## Application for Works Approval

<b>Works Approval Number</b>	W6536/2021/1
<b>Applicant</b>	Genesis Minerals Limited
<b>ACN</b>	124 772 041
<b>File Number</b>	DER2018/001042-5
<b>Premises</b>	Ulysses Gold Project  Legal description Mining Tenements G40/4, G40/5, G40/6, and Part of Mining Tenements M40/166, M40/107, L40/11, L40/12, L40/30 and L40/34  As defined by the coordinates in Schedule 1 of the Works Approval
<b>Date of Report</b>	30 July 2021
<b>Decision</b>	Works approval granted

**Figure 1: TSF embankment construction**

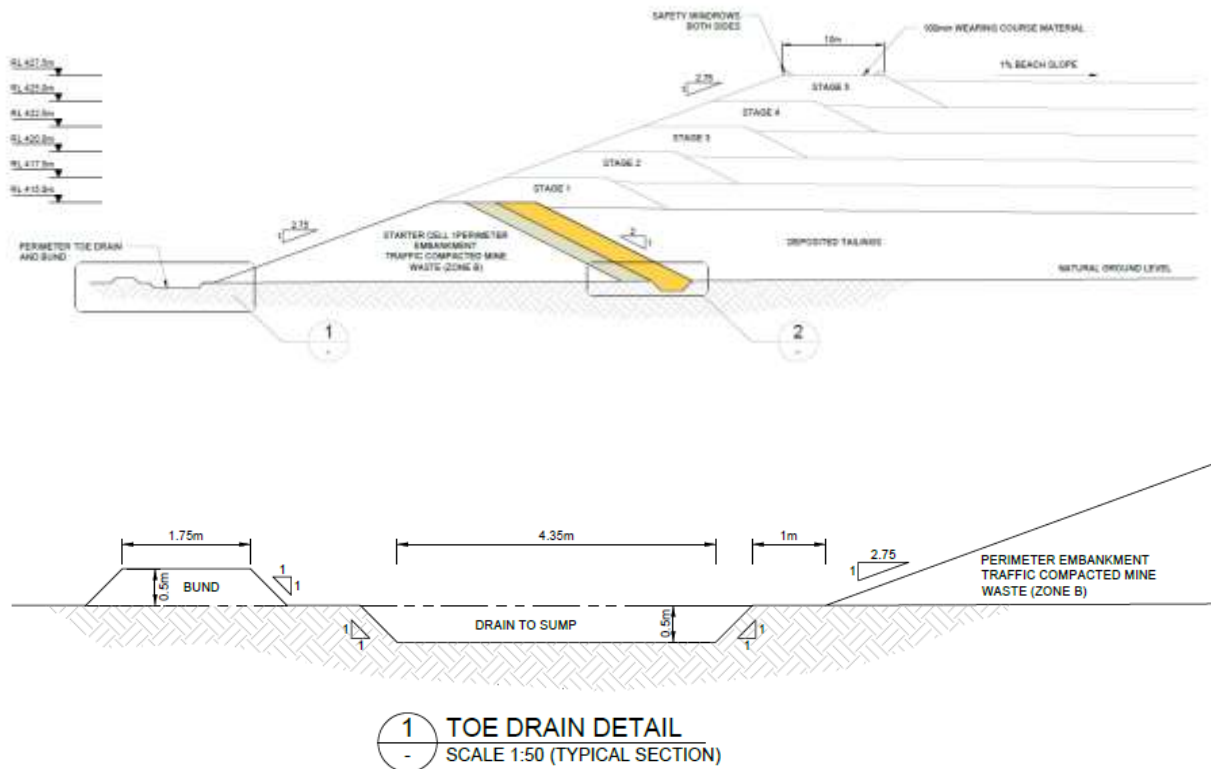
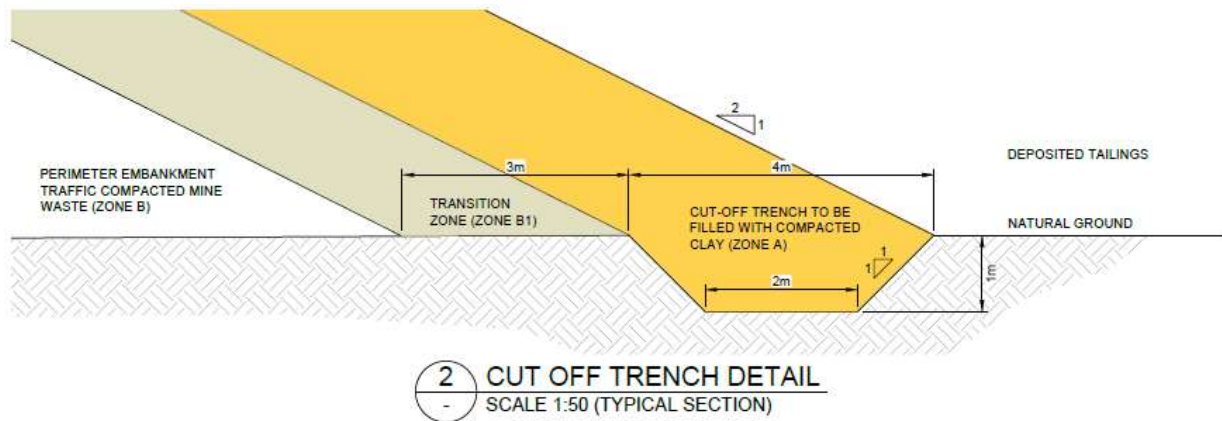
The perimeter embankment of the TSF cells will be constructed using compacted clayey mine waste, borrow fill (Zone A) and traffic compacted mine waste sourced from waste dumps or from the existing open pits (Zone B) as indicated in Figure 1 below. Embankments have design slopes of 1V:2H upstream and an overall 1V:2.15H slope. Subsequent embankment raises will be constructed upstream of the previous embankment height.

**Key finding:** The Delegated Officer notes that the application has proposed five stages for embankment raises to facilitate the anticipated 10 year duration of mining activities.

As works approvals are only granted for five year durations, the first two embankment raises will be considered under this works approval application. The Applicant is advised to seek further approval for subsequent embankment raises when required by operational timeframes.
